SITE PLAN & ARCHITECTURAL COMMISSION AGENDA JANUARY 18, 2019

- 50.1 **AC-18-126** Consideration of a proposal for the construction of a 2,849 square foot restaurant with a drive-thru (KFC) on a parcel totaling 0.76-acres, located at the corner of Garfield Street and Center Drive (1408 Center Drive) in the Regional Commercial (C-R) zoning district (371W32B TL 4801 & 3605); (Barry Thiriot, Applicant; Phillip Moss, Agent; Dustin Severs, Planner).

for a Type-III quasi-judicial decision: **Site Plan and Architectural Review**

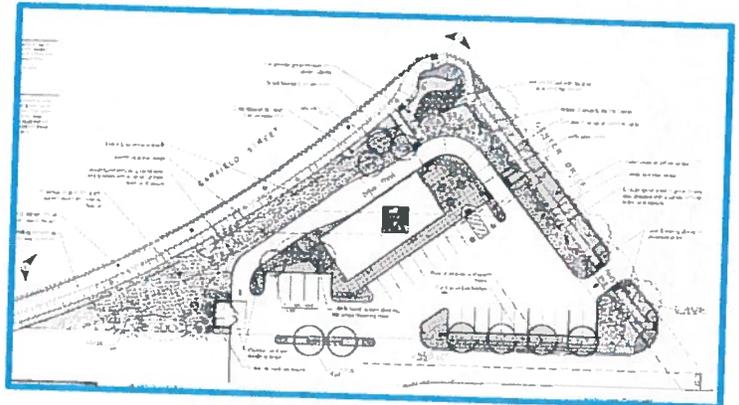
The submitted landscape plan (Exhibit H), shows landscaping along all three street frontages of the site, and located within the parking area; however, the plan is deficient the minimum number of trees required to be located within the parking area and along all three street frontages.

As a condition of approval, the applicant will be required to submit a revised site plan showing the required number/amount of trees, shrubs, and coverage area, pursuant to MLDC 10.746 and MLDC 10.797.

Vehicular Access

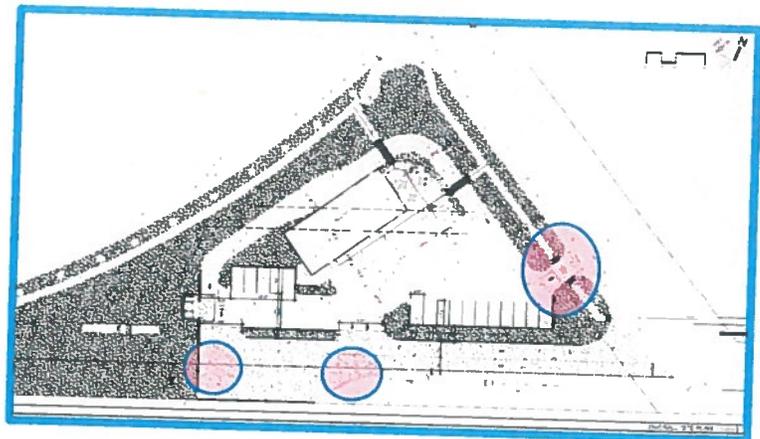
The site plan shows a vehicular entrance to the site via a driveway off of the future Belknap Road. The site plan also shows a second drive off of the future Belknap Road, identified as *exit-only*, and another *exit-only* drive off of Center Drive

Trash Enclosure (Exhibit I)

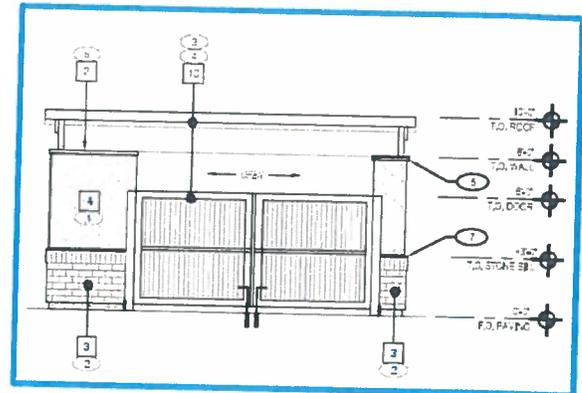
The trash enclosure plan (Exhibit I) identifies 10-foot high gated trash enclosure with brick veneer/cement plaster exterior and a metal roof, and the site plans shows the trash enclosure located to the southwest corner of the site, consistent with the requirements found in MLDC 10.781.
